**Subject:** Comments for the Plan Commission in support of 126 Langdon Street

I am writing in support of agenda item 20, The Hub II to be located at 126 **Langdon** Street.

**Re: Support for Construction of The Hub II at 126 Langdon Street**

Plan Commission  
Meeting of July 27, 2020  
Agenda Item #20, Legistar #58786

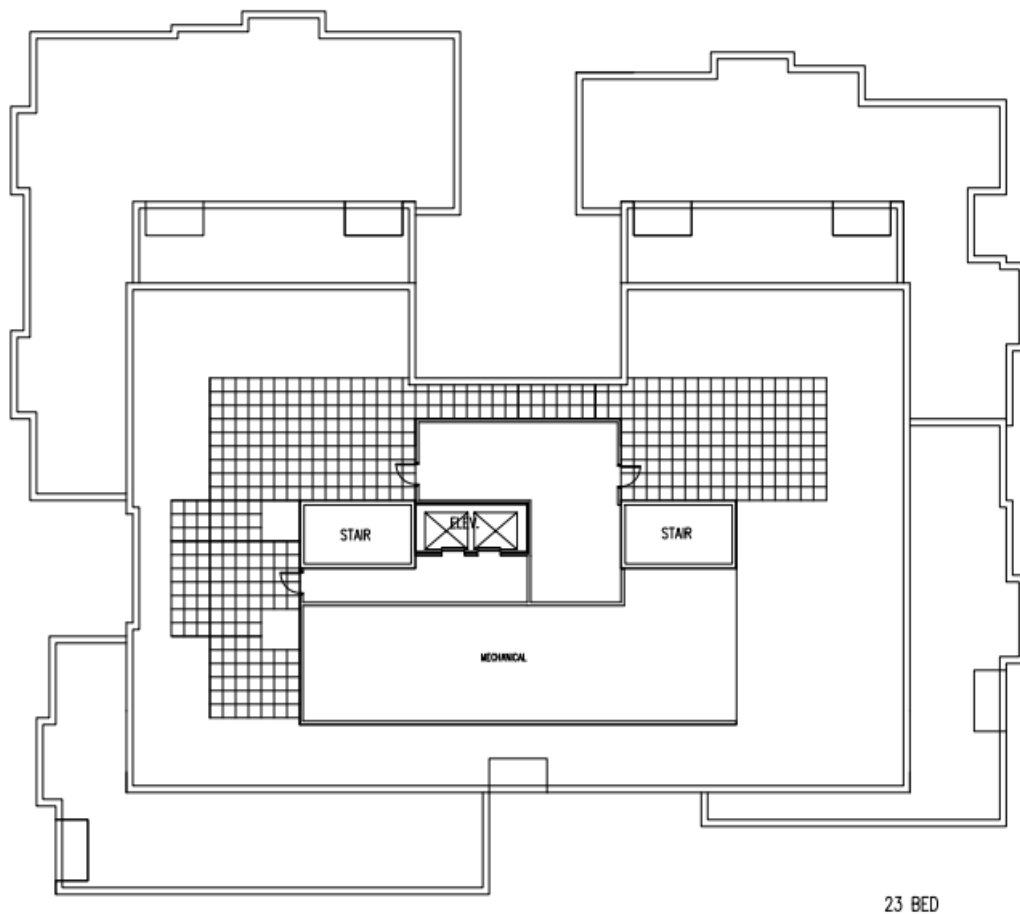
Old 126 street width 40, project street width 131 (the setback tower portion is about half the width), or about 225% wider.

Old 126 61,600 gross square feet, project 148,514 square feet, or 141% greater.

Newer (eastern) building of the Edgewater hotel: height 85 feet; footprint 16,700 (approx.).

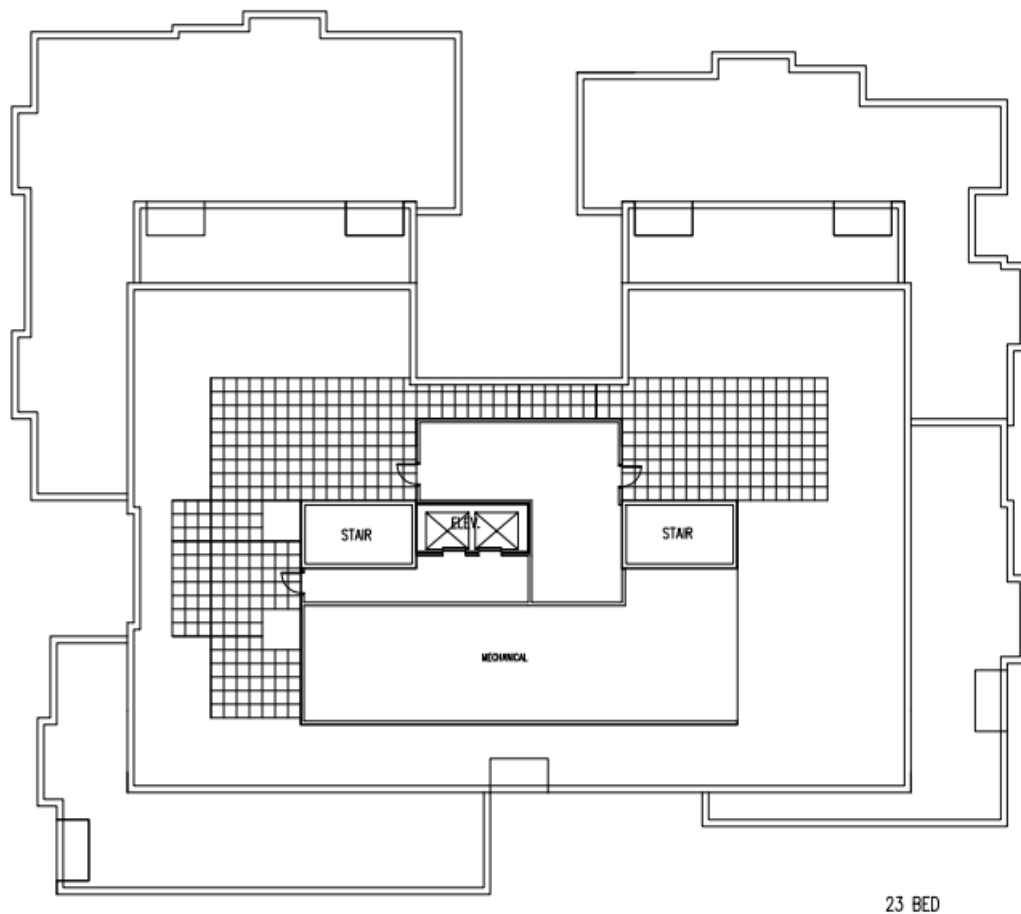
Old 126 street width 40, project street width 131 (the setback tower portion is about half the width), or about 225% wider.

Old 126 61,600 gross square feet, project 148,514 square feet, or 141% greater.

Newer (eastern) building of the Edgewater hotel: height 85 feet; footprint 16,700 (approx.).
